# Colston Budd Rogers & Kafes Pty Ltd

Our Ref: TR/12161/mc

**RE: SOUTH AUSTRAL SHOPPING CENTRE  
RESPONSE TO TRAFFIC MATTERS**

1. As requested, we have reviewed the traffic matters raised in Council's RFI letter dated 11 March 2024. We prepared the Traffic Report<sup>1</sup> that was submitted with the development application.

Existing weekday morning  
peak hour traffic flows plus  
development traffic  
**Figure 2**

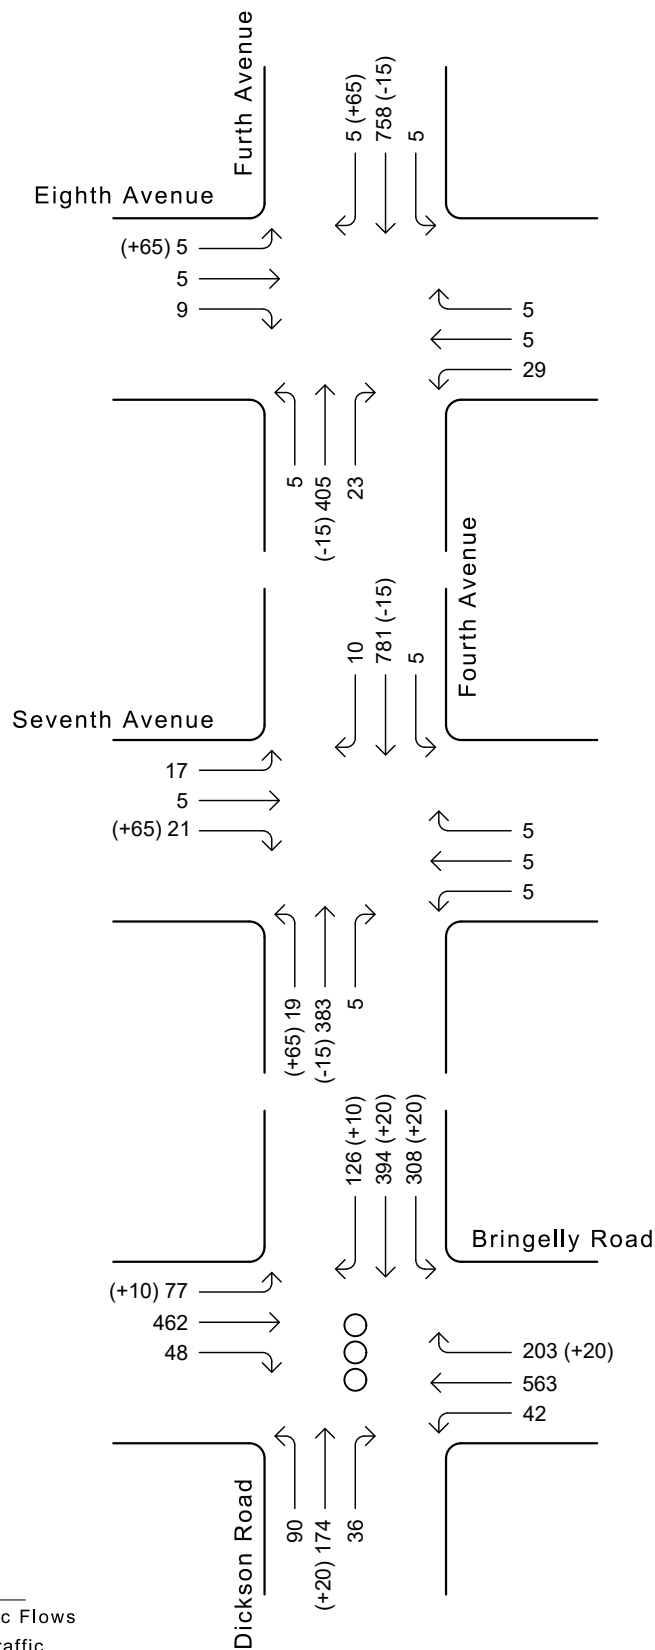
- *Road name labels on figure 2 and figure 3 in the traffic report should be amended to utilise correct identifications (i.e. Rickard Road should be Dickson Road).*

17. **Response:** Updated Figures 2 and 3 are attached.
18. We trust the above provides the information you require. Finally, if you should have any queries, please do not hesitate to contact us.

ATTACHMENT A

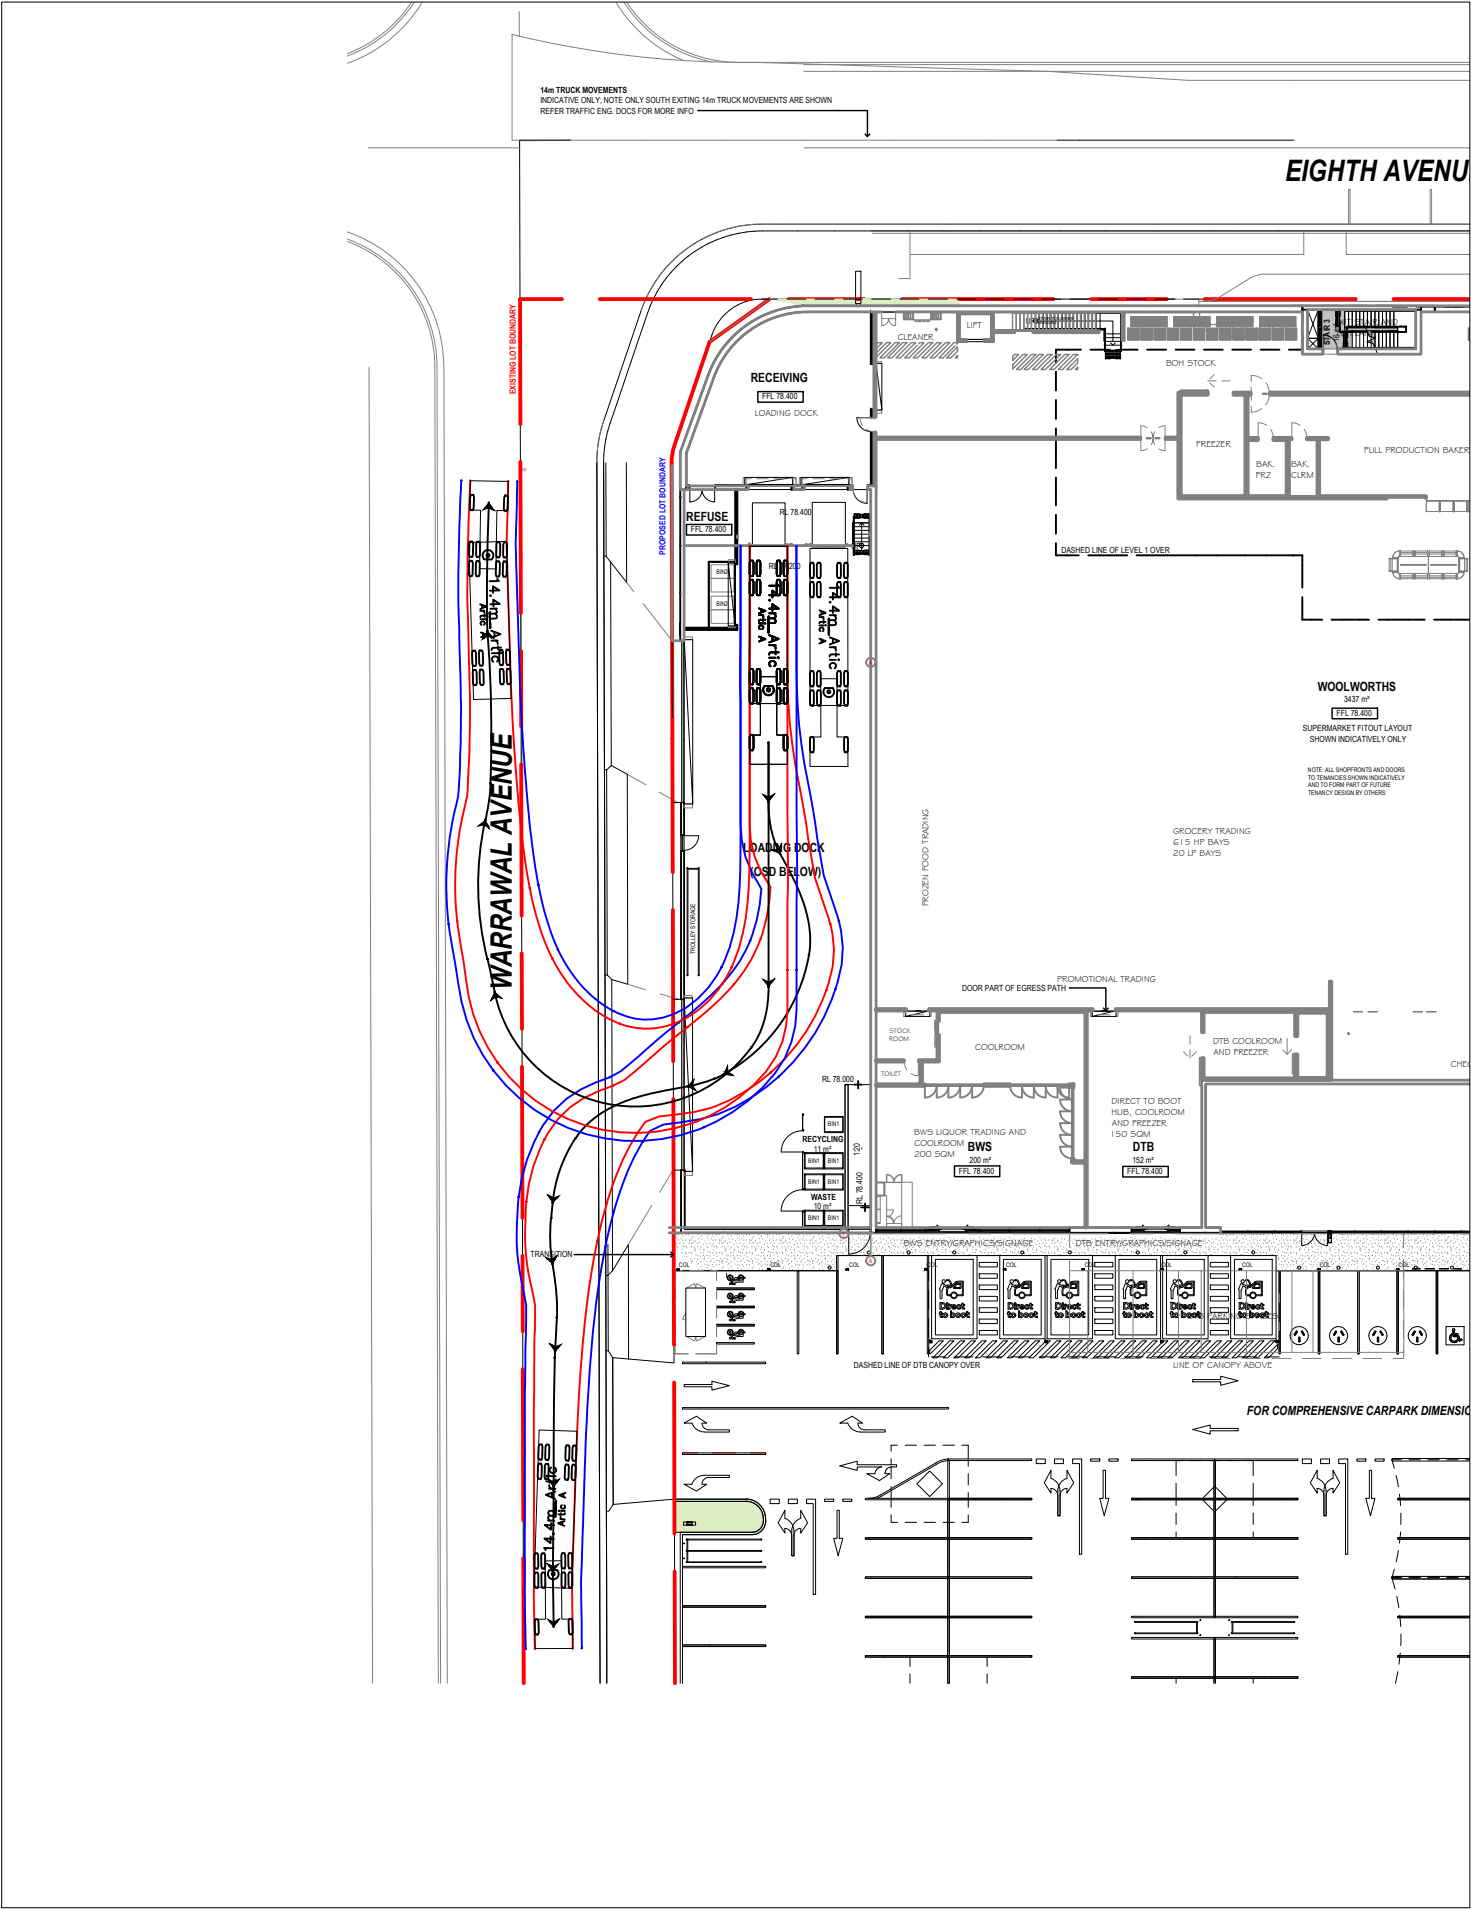
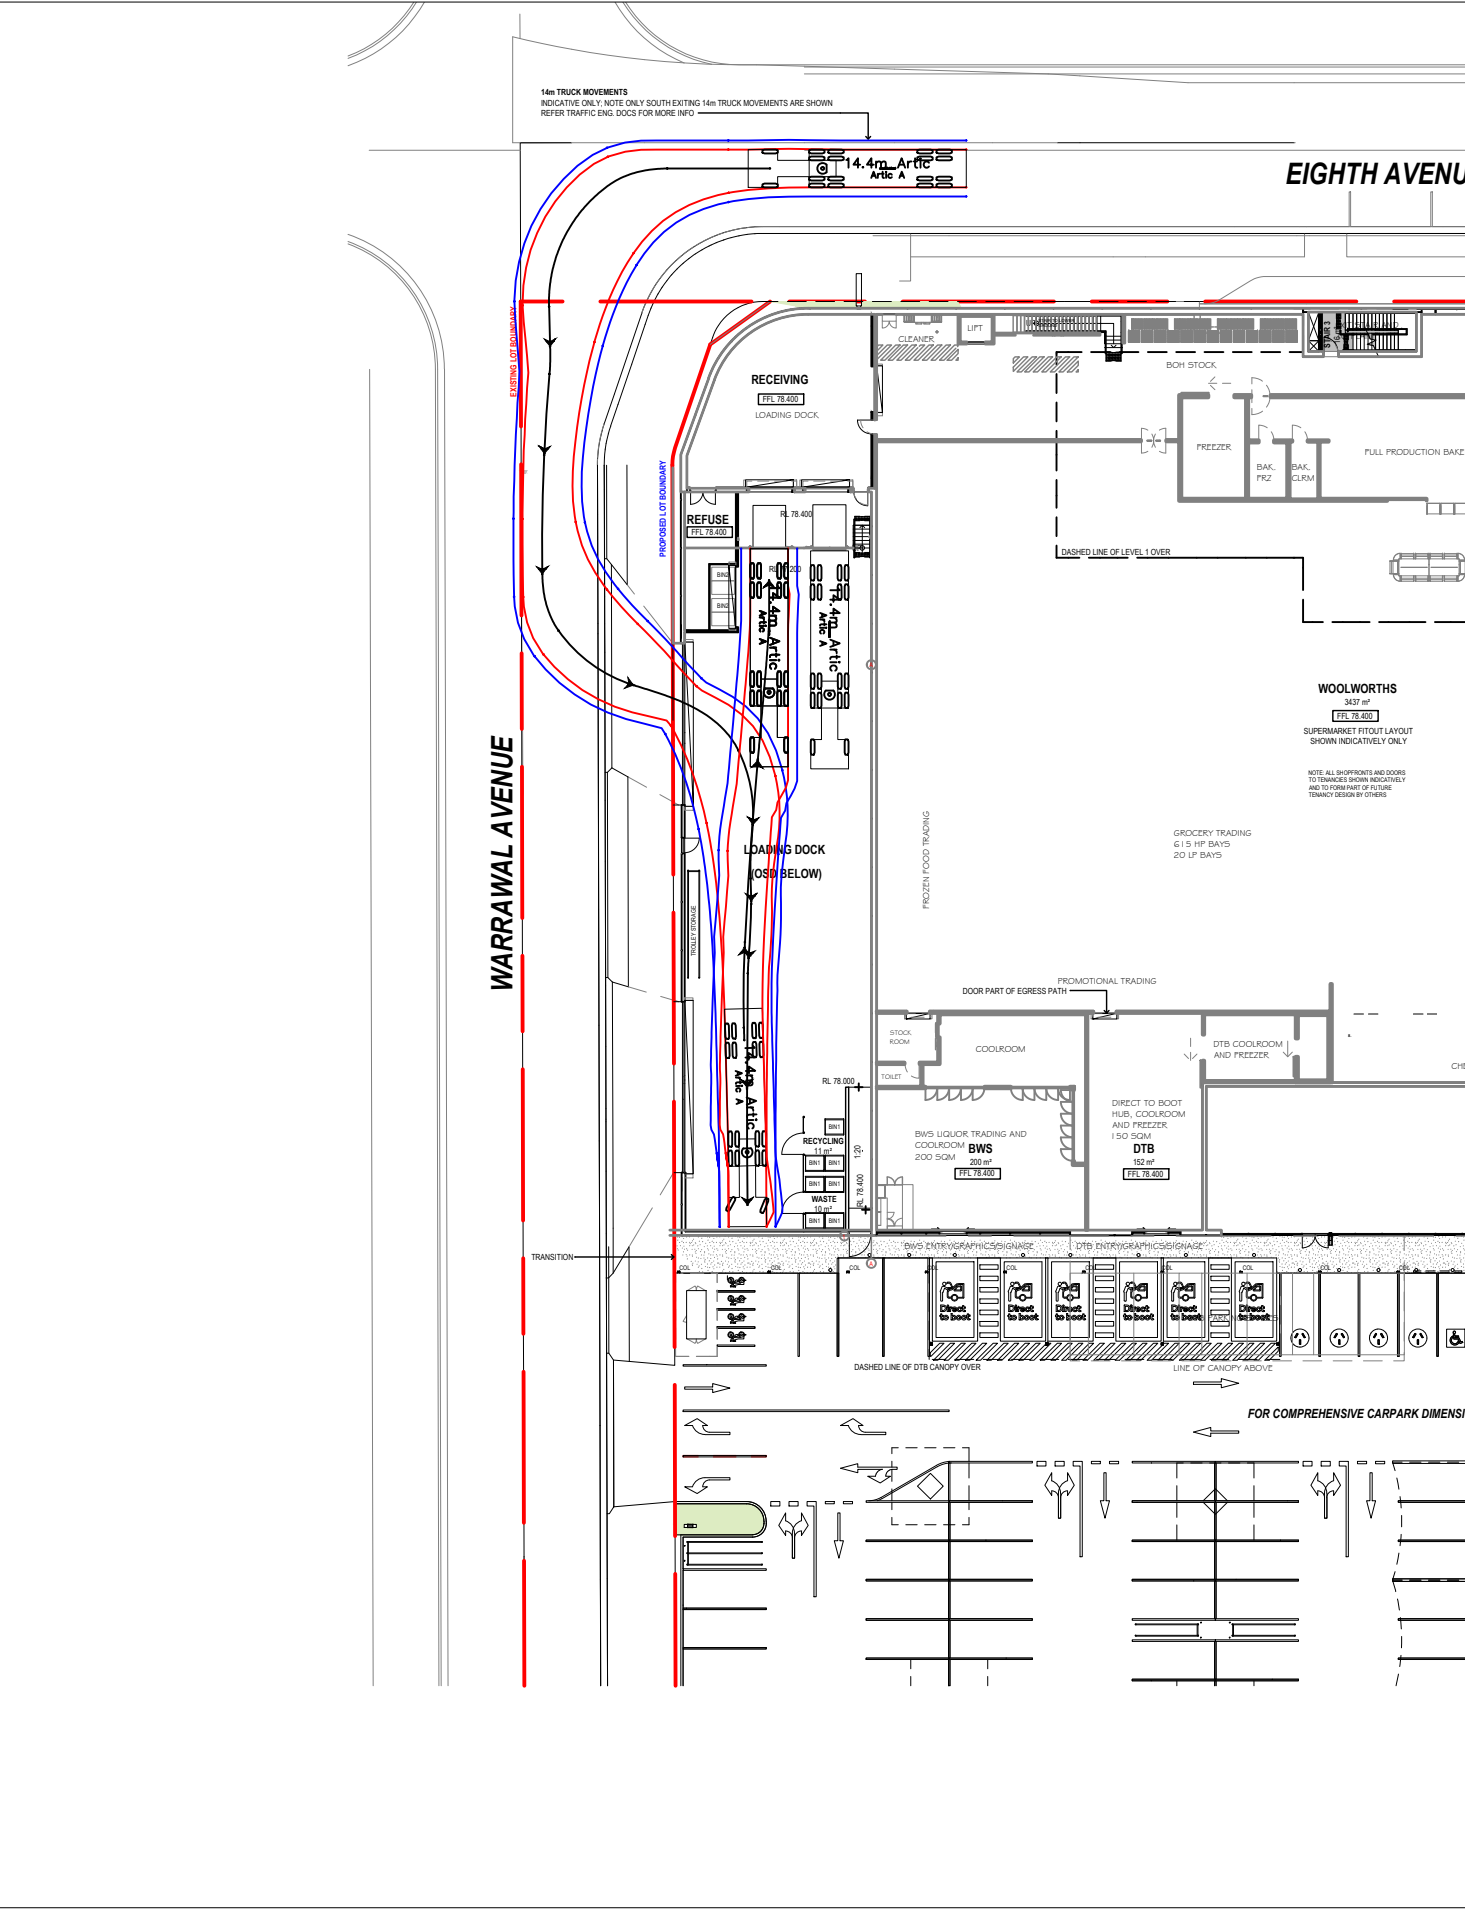
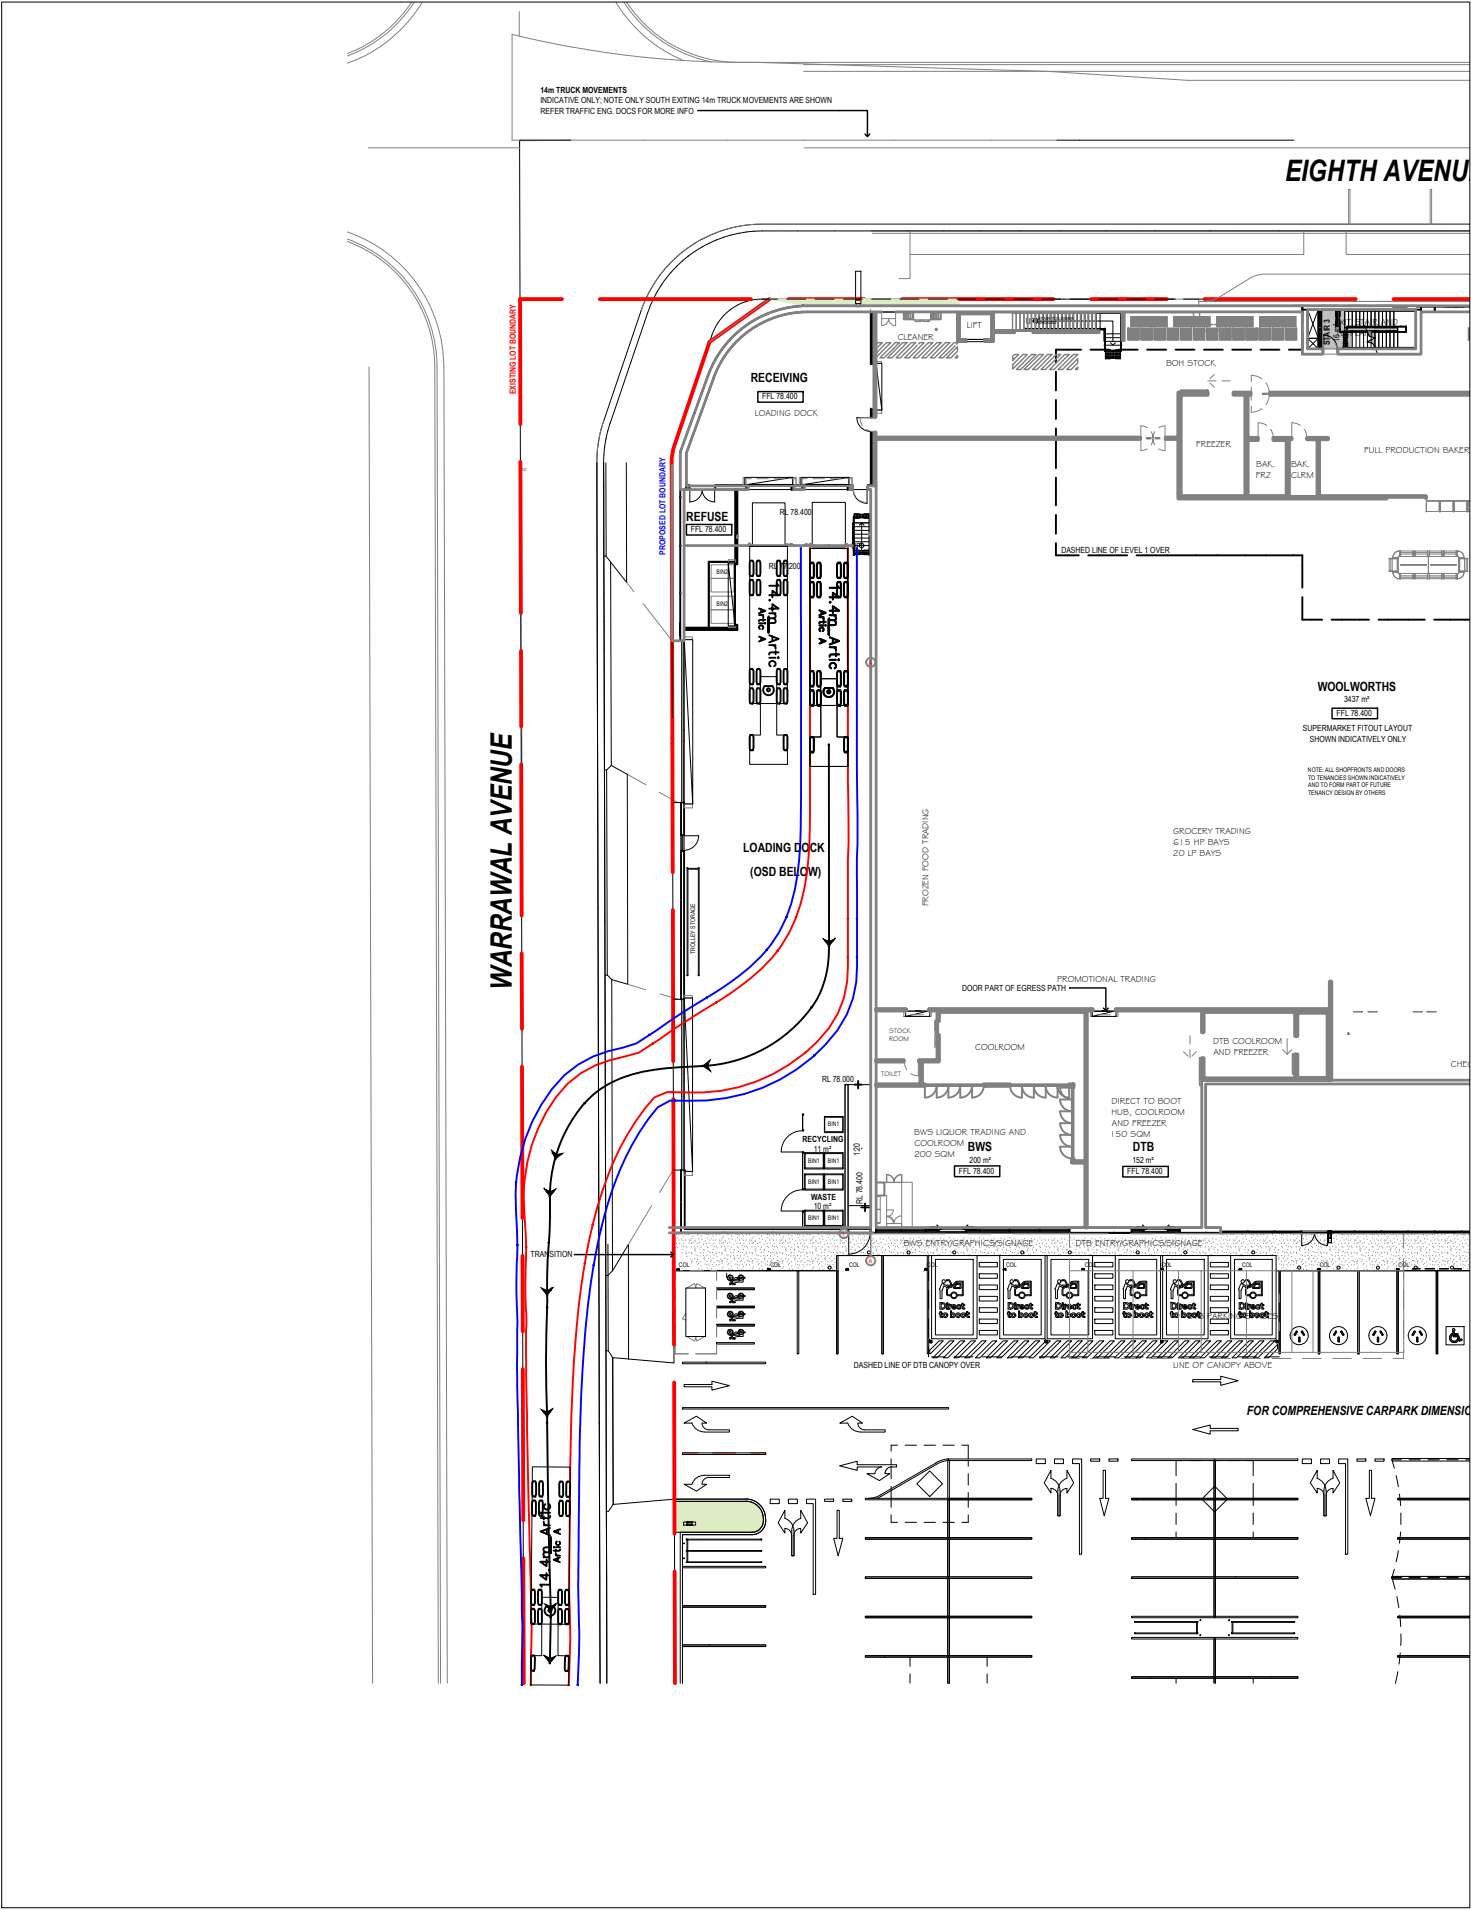
*The submitted Traffic Impact Assessment recommends that an additional two loading bays (6 metres long by 3 metres wide) are provided in the northeast corner of the car park. These bays will cater for vans and couriers servicing the specialty shops and commercial area. The submitted plans do not show where the additional loading bays would be. Amended plans and documentation must demonstrate that parking provision is not impeded by any additional loading bays.*

10. The amended plans prepared by CHC show minor modifications to the loading dock (new waste facility) and at-grade car park (provision of two loading bays (6 metres long x 3 metres wide) in the northeastern corner of car park (for vans and couriers) and relocation of the DTB spaces two spaces to the west). Updated vehicle swept paths are provided in Attachment A.

13. **Response:** Amended plans prepared by CHC show two additional loading bays in the northwestern corner of the car park (adjacent to the specialty retail tenancies).
